RE: Additional Site Study
Avery County Landfill
Newland, North Carolina

Subject: Notice of Incomplete Demonstration for Site Suitability and Technical Review Letter, Hydrogeologic Investigation Report, Revised Site Study, C&DLF Expansion Avery County, Permit #06-03. Doc ID No: 6258

TITLE: AVERY COUNTY C&D LANDFILL PROPOSED PIEZOMETERS FOR ADDITIONAL SITE STUDY

FIGURE NO. 1	FILE NAME AVERY-B0078
SCALE: AS SHOWN	PROJECT NO. AVERY 08-7
CHECKED BY:	
DRAWN BY: J.A.L.	DATE: Feb. 2009

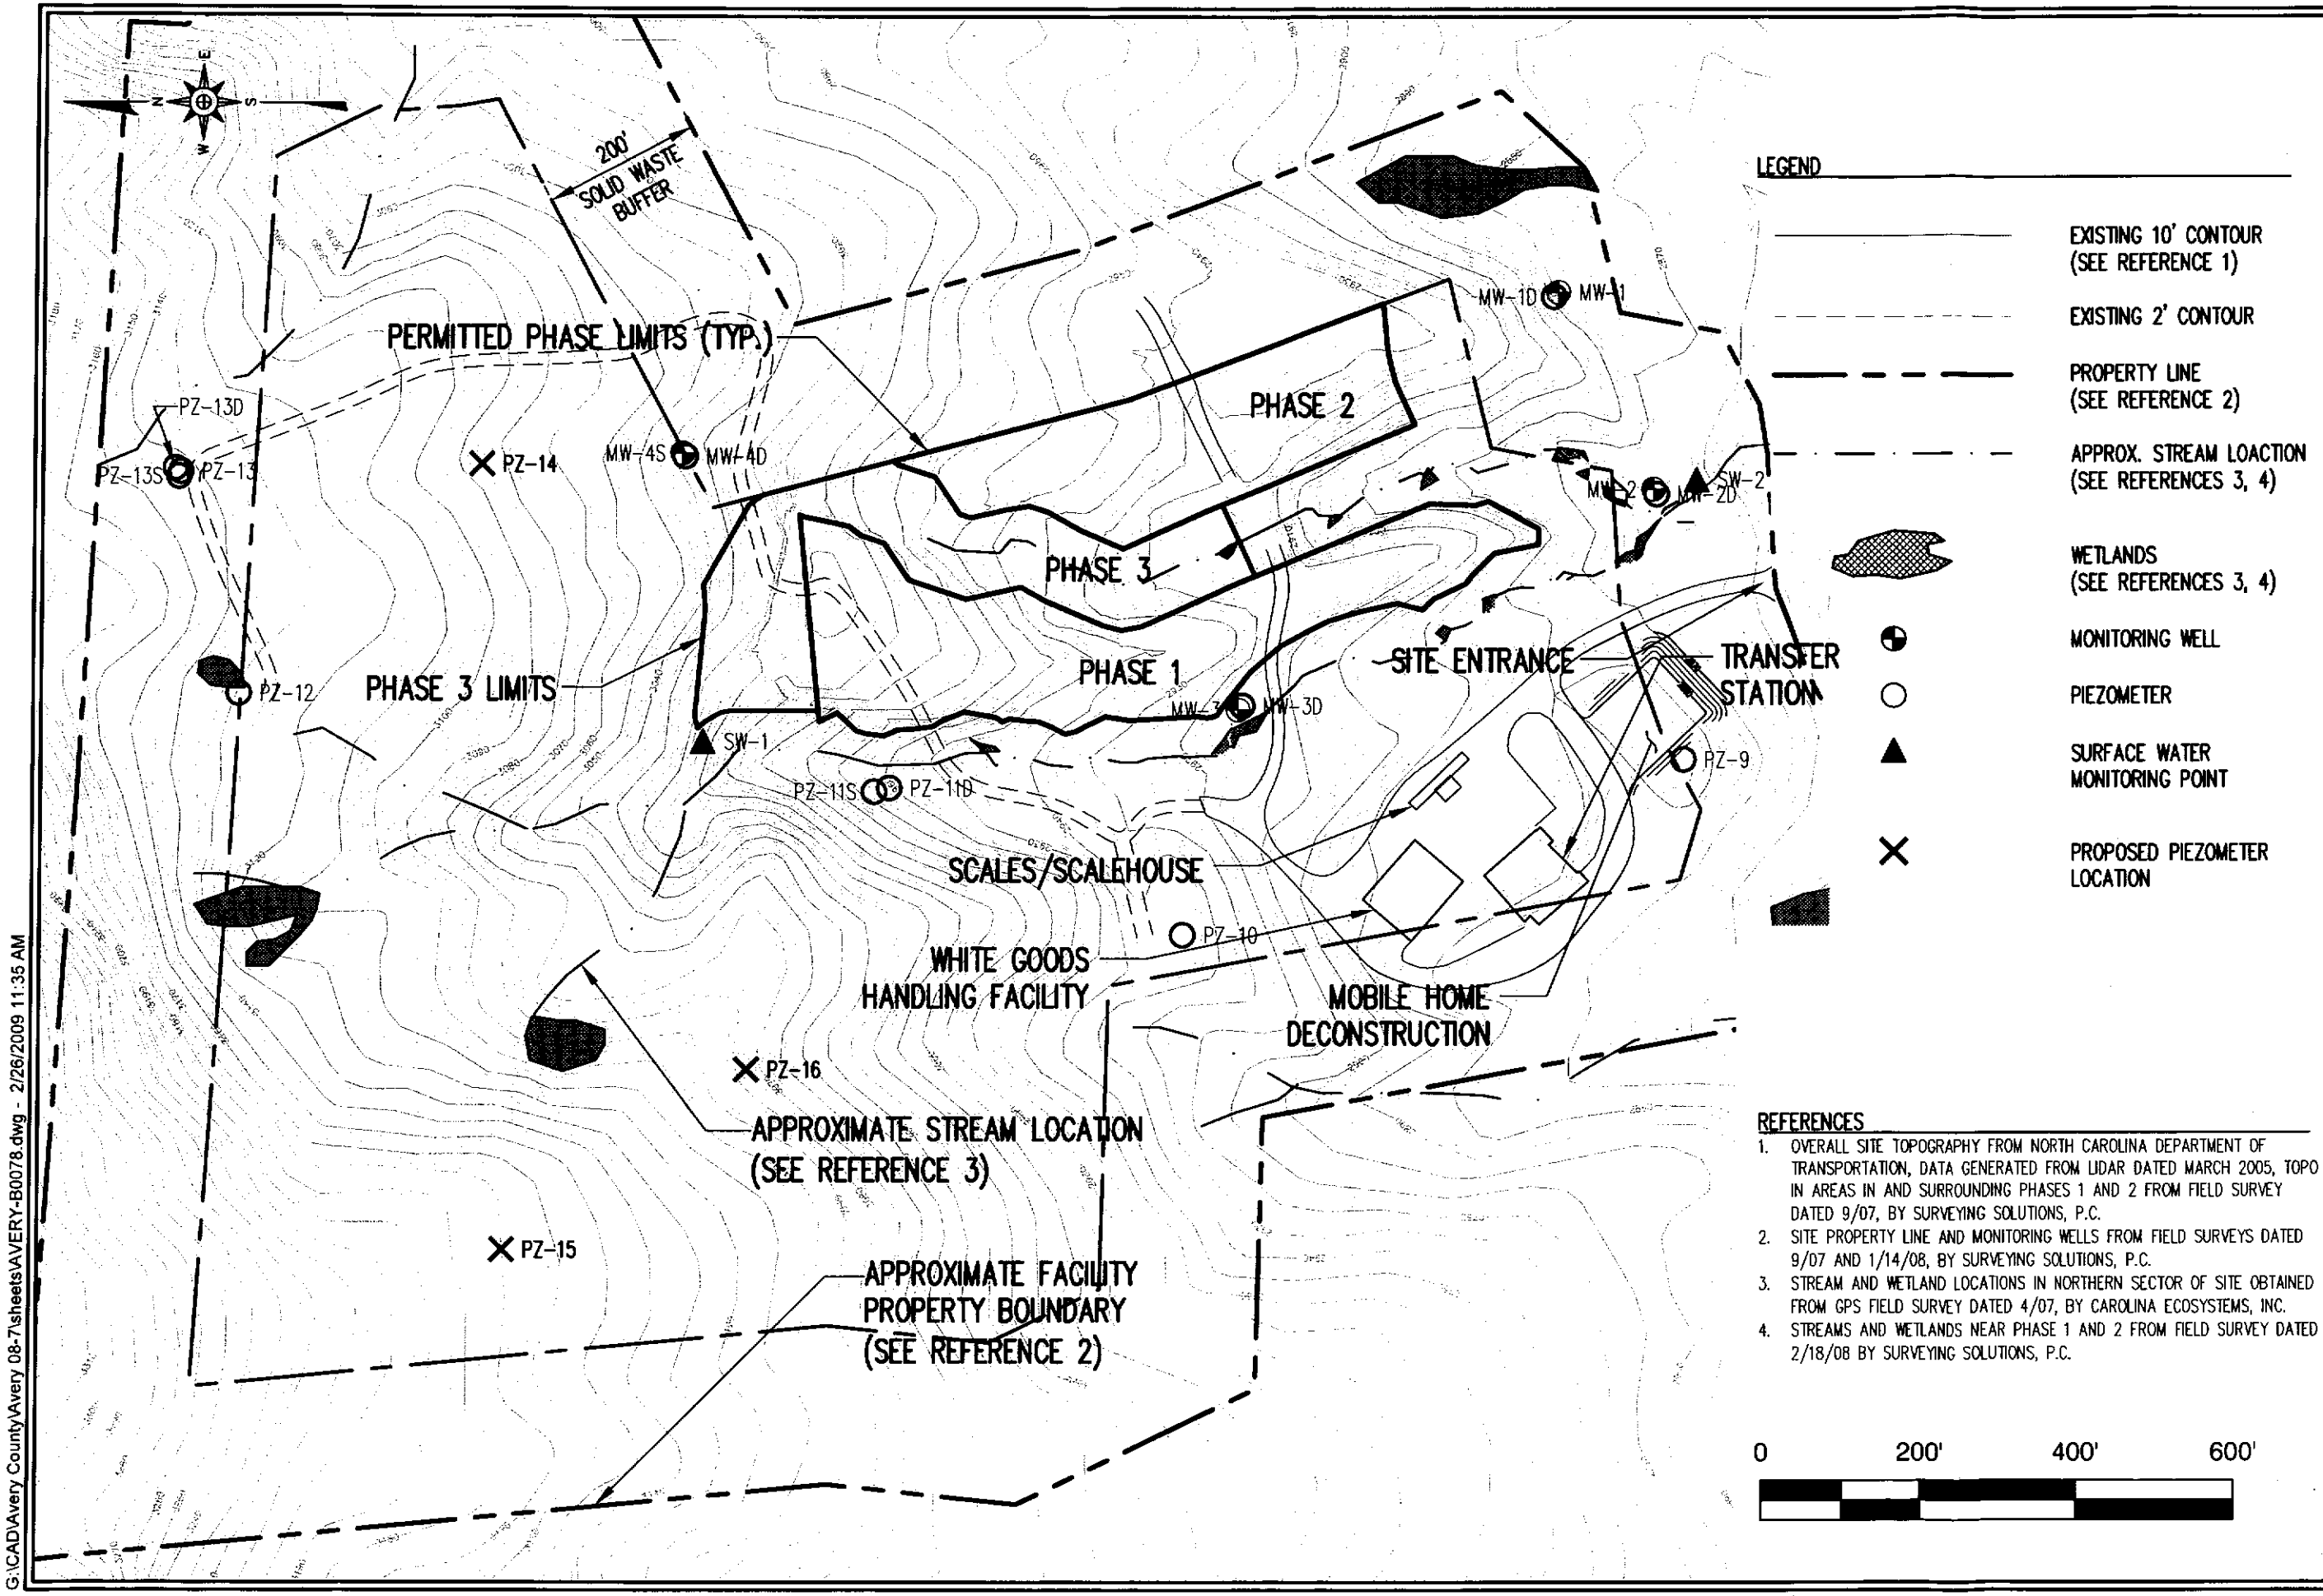
The Hydrogeologic Investigation Report, dated April 2008, included in Appendix C, failed to adequately assess geologic and hydrogeologic characteristics of the proposed site pursuant to 15A NCAC13B .0538(a). Foremost, there is an insufficient number of borings within and around the proposed expansion area North of existing Phases 1 and 2 on the Eastern portion of the property and within and around the proposed expansion area on the Western portion of the property. Although part of Rule .0538(a)(3) specifies a minimum ratio of borings to acreage, another part specifies that the number and depths of borings will "depend on the hydrogeologic characteristics of the site." The Rule further stipulates that the numbers, locations, and depths of borings should be sufficient to provide adequate understanding of subsurface conditions and the groundwater flow regime of the uppermost aquifer. Avery County's mountainous terrain requires more data than what suffices in hilly and coastal terrain. No determination on site suitability can be made without sufficient numbers, locations, and depths of borings to characterize geologic and hydrogeologic conditions of the entire site proposed for expansion.

Richardson Smith Gardner and Associates, Inc. (RSG) will install three additional piezometers (labeled PZ-14, PZ-15 and PZ-16) as shown on the attached **Figure 1**. One (1) of these piezometers, PZ-15, will be installed to the depth of bedrock (approximately 90 feet below grade). The remaining two (2) piezometers, PZ-14 and PZ-16, will be installed to a depth approximately 10 feet below the water table surface.

All three borings will be drilled by hollow stem auger with standard penetration test samples being collected every five feet of auger advancement. Two undisturbed Shelby tube samples will also be collected from piezometer PZ-15. Each boring will be completed as a piezometer with 10 feet of 10-slot screen and solid PVC riser pipe to approximately 3 feet above grade. Lockable steel outer casings will be installed on each piezometer to maintain long term viability of the piezometer. A well tag will be completed for each piezometer and affixed to the outside of the outer steel casing.
